## Important Customer Information - March 18<sup>th</sup>, 2009 Von Arx VA 30 SH Surface Preparation Machine

**Picture 1 Old Version until  
March 17th, 2009**

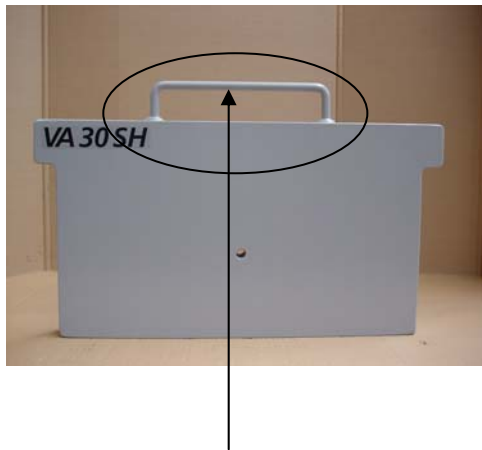
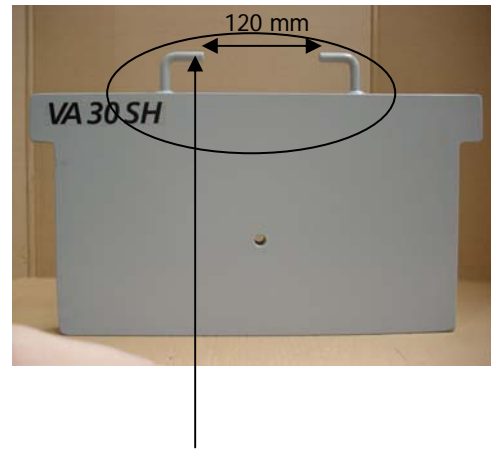
Due to safety reason we have made the following modification starting from March 18<sup>th</sup>, 2009 regarding the additional 30kg weight that comes with the Von Arx Surface Preparation machines VA 30 SH with Honda engine and electro motor. The handle shown in the pictures below has only to be used to put in place or remove the additional weight.

**Do not use the handle to lift the complete machine.  
Attention serious injury danger!**

In case that you already have an additional weight (see picture 1), we kindly ask you to implement the modification to the handle according to the new version (see picture 2).
